Project: Pitchcombe Junction Revision A

Subject: Development of Design Proposals Provided by Gloucestershire Highways

The aim of this technical note is to explain the issues related to implementing the design provided by GH.

SWEPT PATH ANALYSIS

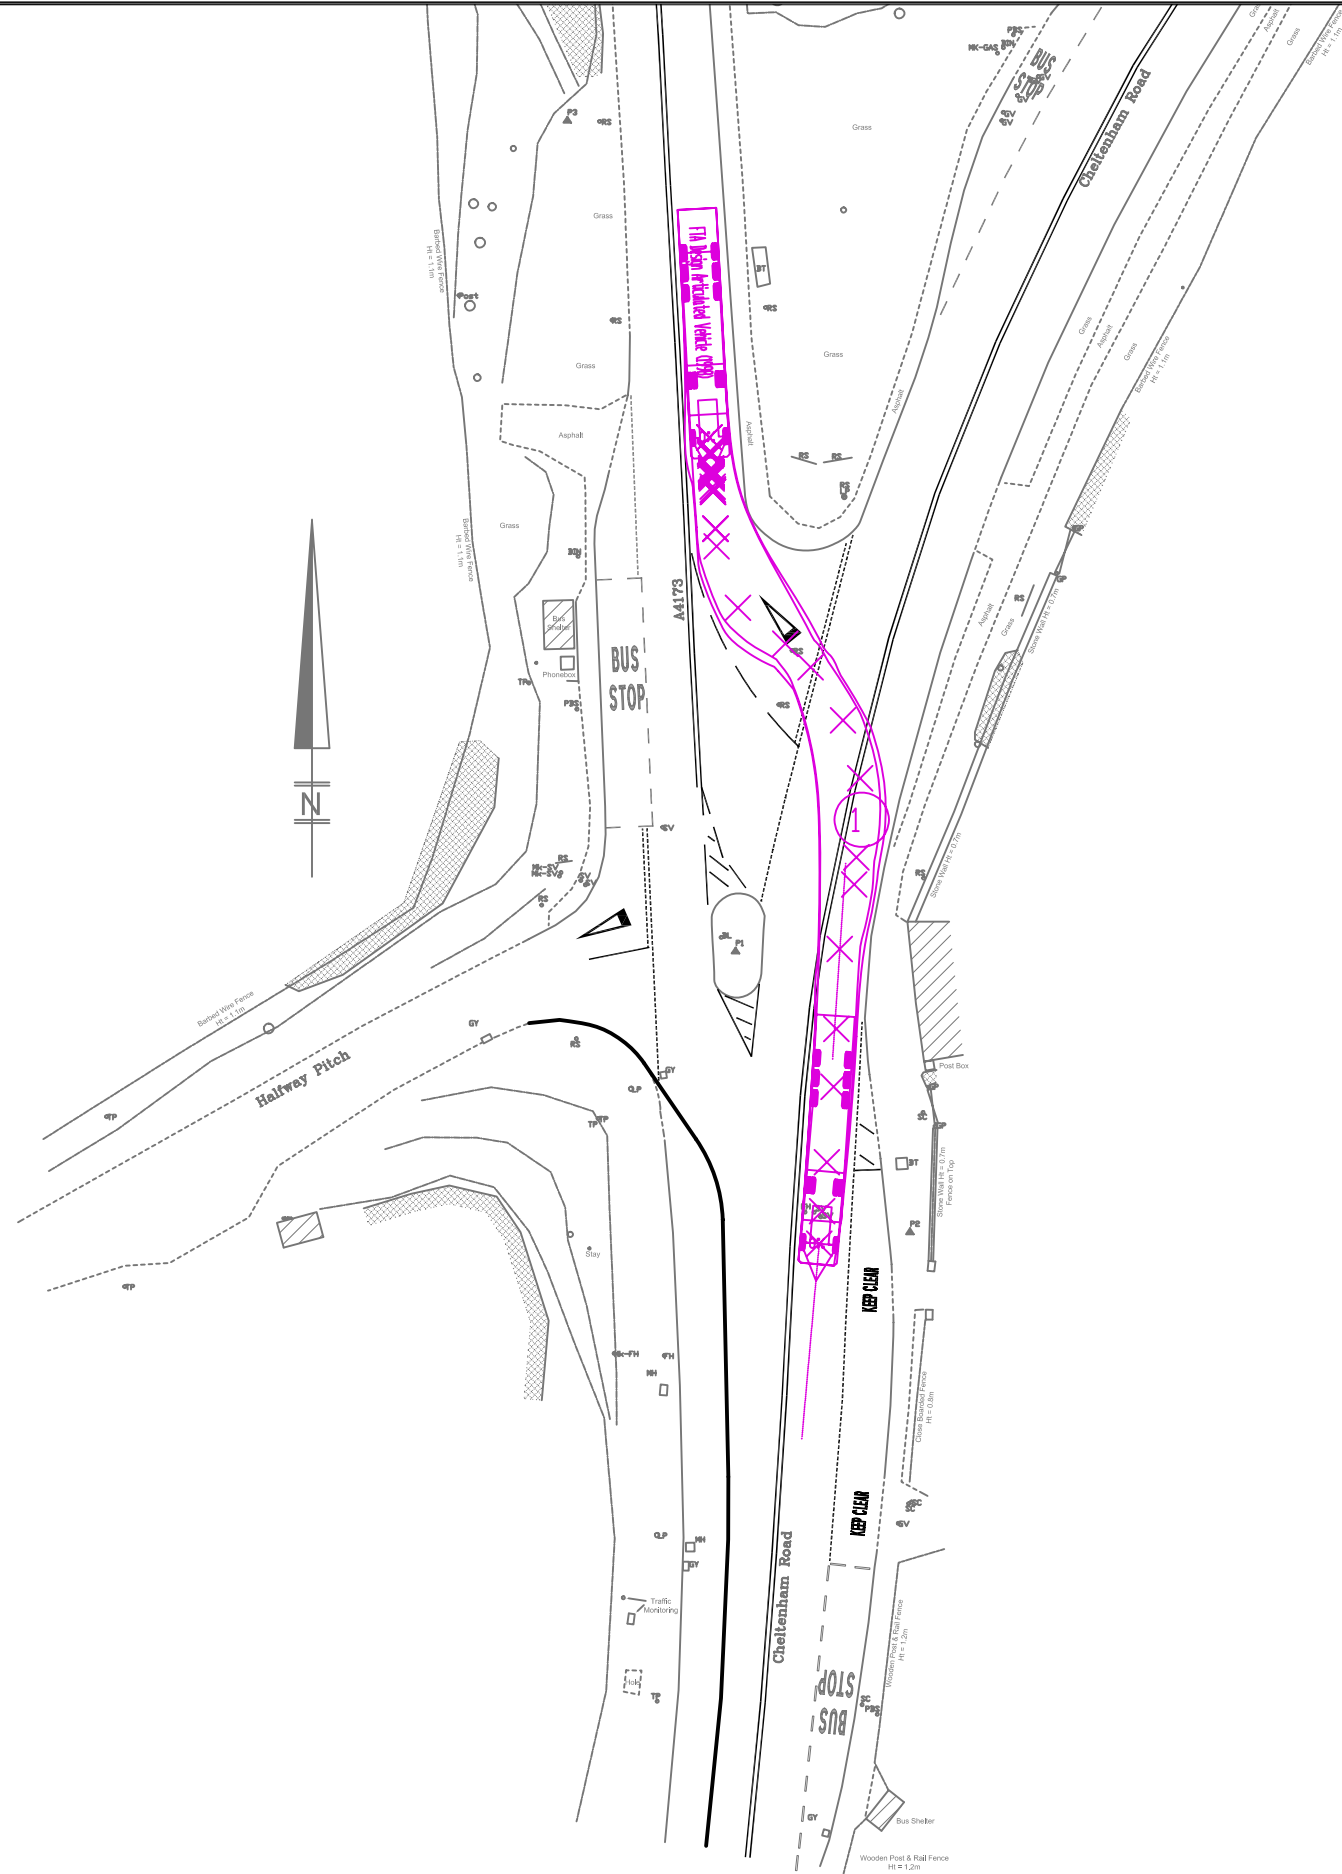
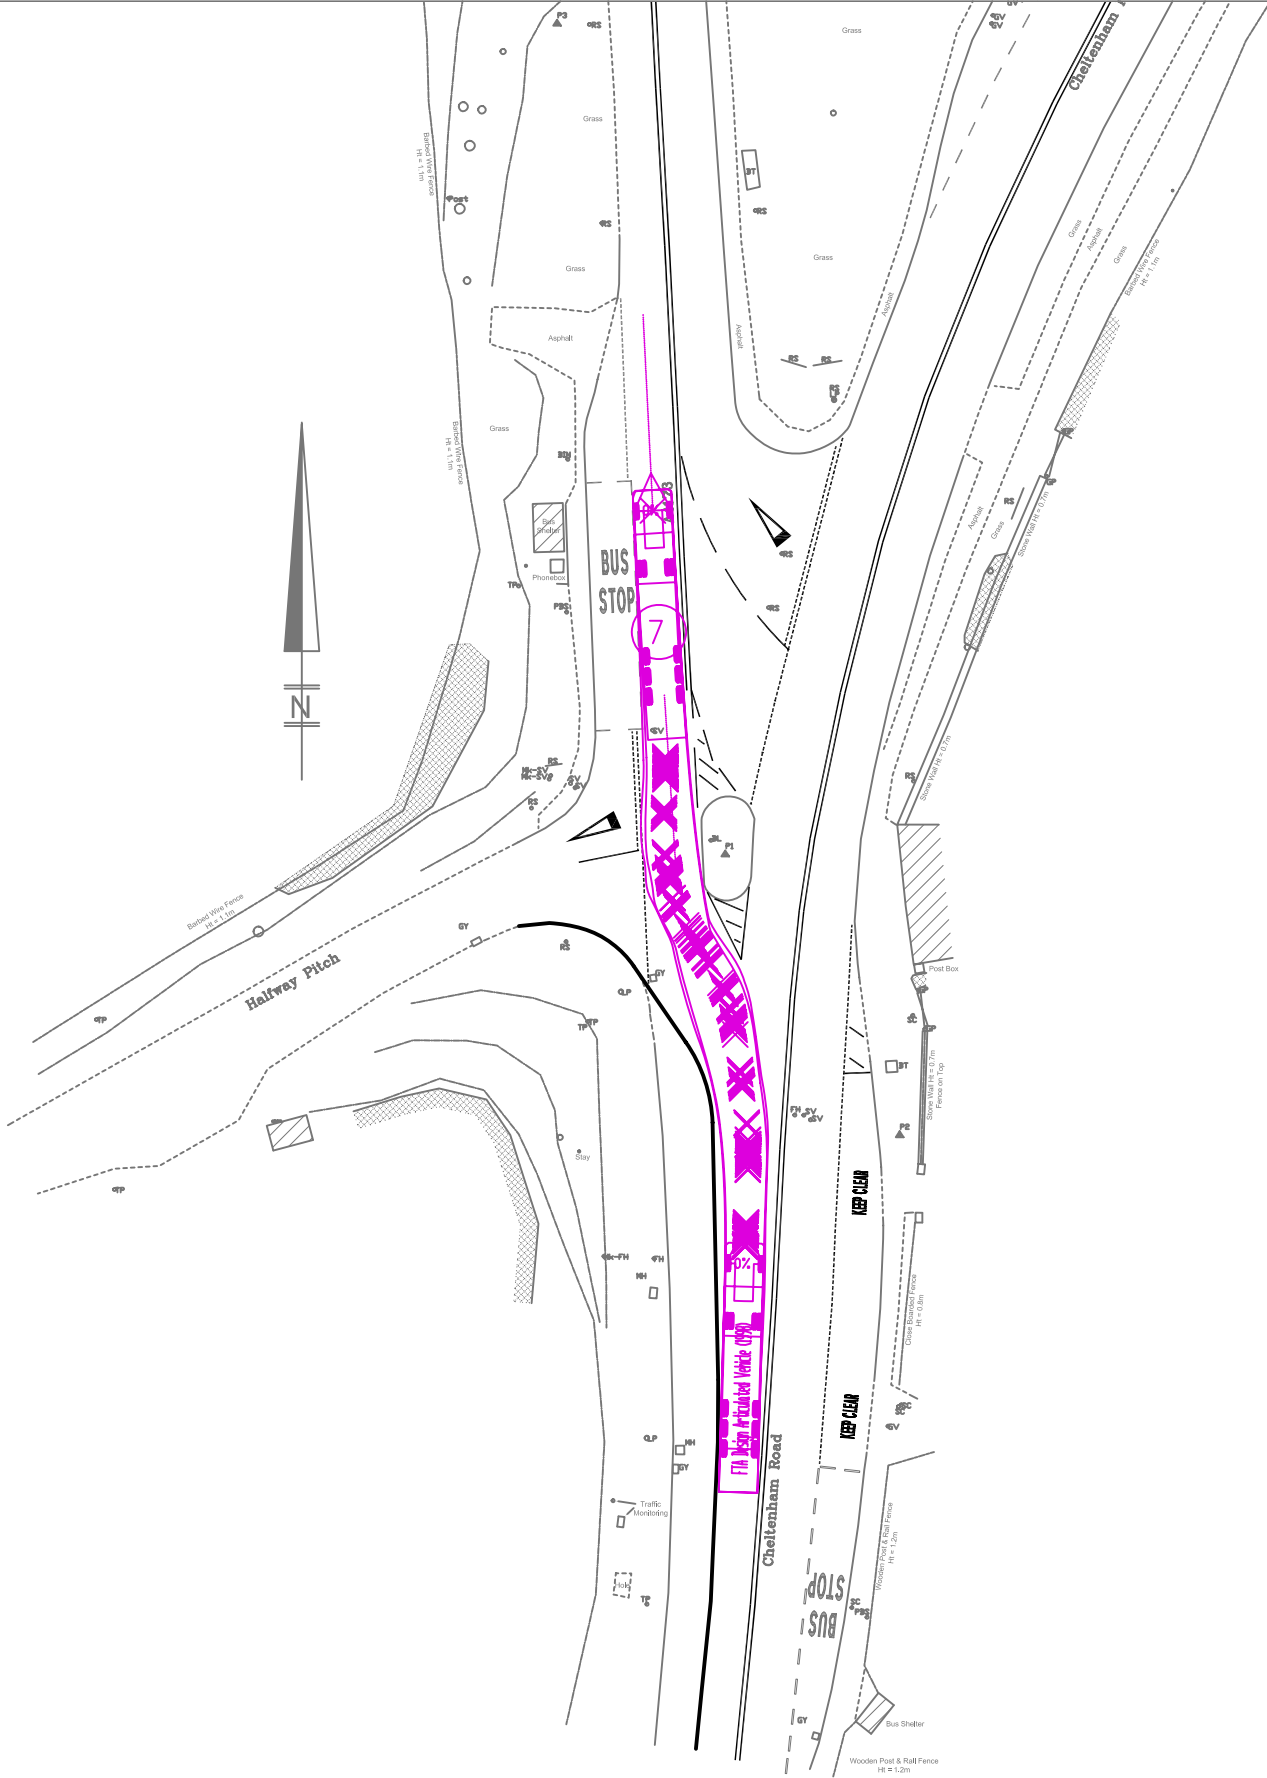
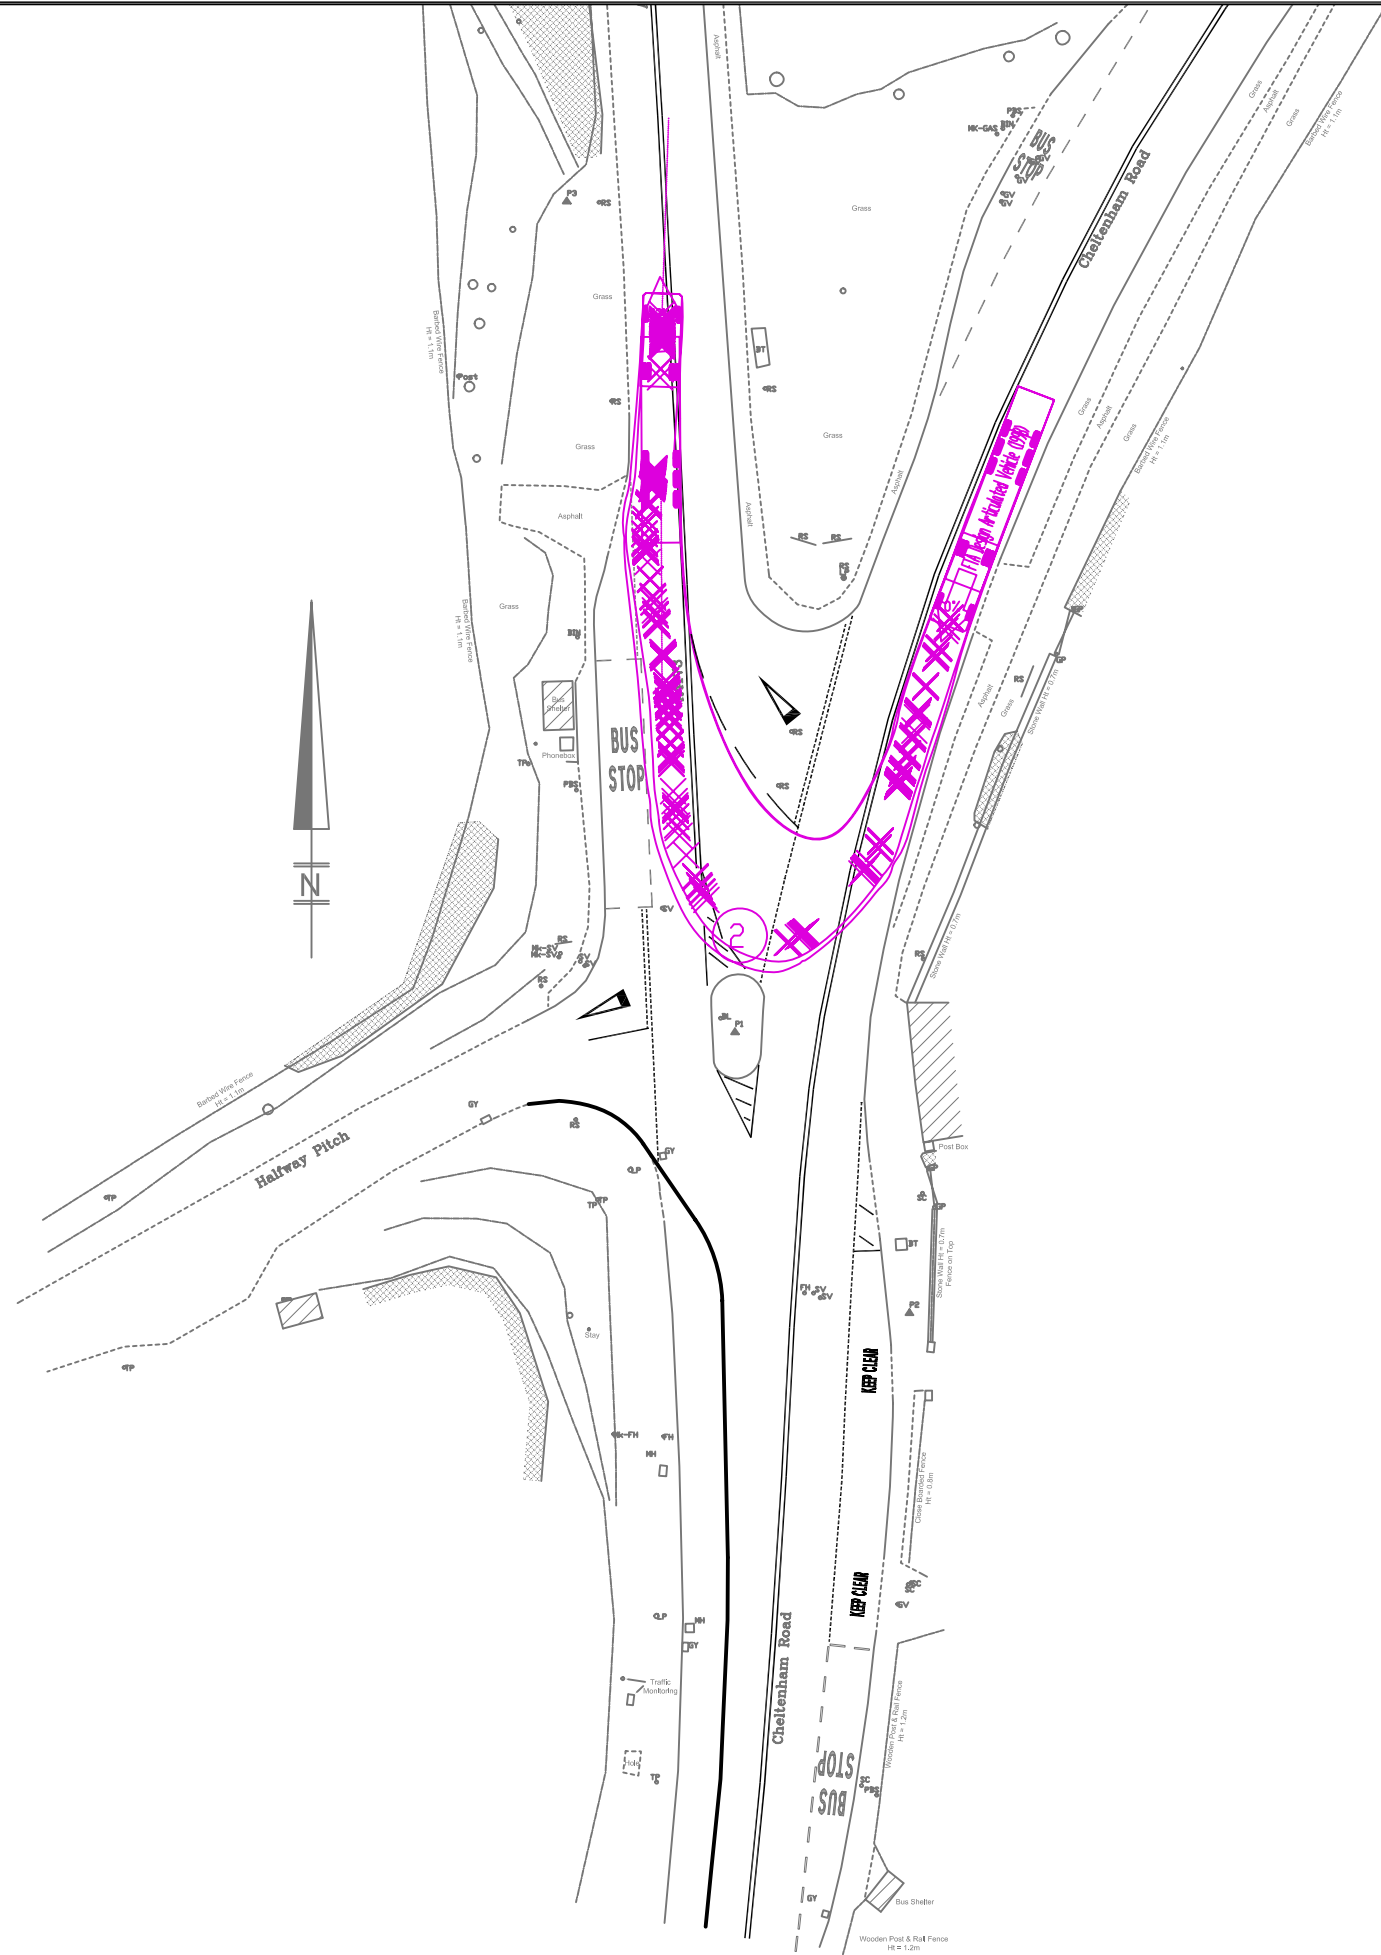
The proposed design was checked using Autotrack software to ensure that the following movements are achievable: the design vehicles were a 16.5 metres articulated vehicle and a fire tender.

- Right turn movement off the A4173 and onto the A46 southbound
- Right turn movement off the A46 southbound and onto the A4173 northbound
- Continuing left on the A4173 northbound off the A46 northbound
- Right turn out of Halfway Pitch onto the southbound lane of the A46 .Due to the presence of existing and proposed island this manoeuvre can only be achieved if vehicles initially make a left turn onto the A4173 before turning right onto the A46. It is suggested that hatched road markings are introduced along the top edge of the proposed island in order to encourage

vehicles to use the widened carriageway (including the incorporated bus lay-by space) and ultimately further facilitate this difficult manoeuvre.

It is important to note that the tracking of vehicle movements dictated the layout of the junction. This resulted in the size of the island being smaller than that proposed by GH and a very wide junction between the A46 and the A4173.

The tracking of the turning manoeuvres shows that all these movements can be accommodated within the existing carriageway boundary and no land acquisition will be necessary other than the incorporation of the bus lay-by. However, the vehicle movements are far from ideal and whilst technically possible some of the more difficult manoeuvres would be at the limit of the design vehicle's capability.

Two right turn bans will be required to enable this junction layout to work. They are the movement from the A46 southbound to Halfway Pitch and the movement out of Halfway Pitch southbound onto the A46. This latter movement could be accommodated by initially turning left onto the A4173 and heading north for a short distance before undertaking a 180° turn into the A4173 junction with the A46. This manoeuvre would be difficult for anything larger than a car and impossible for anything larger than a fire tender. Furthermore, if there is 1 or more vehicle already queuing at the A4173 southbound give way line then it is not possible for any vehicle to make this manoeuvre.
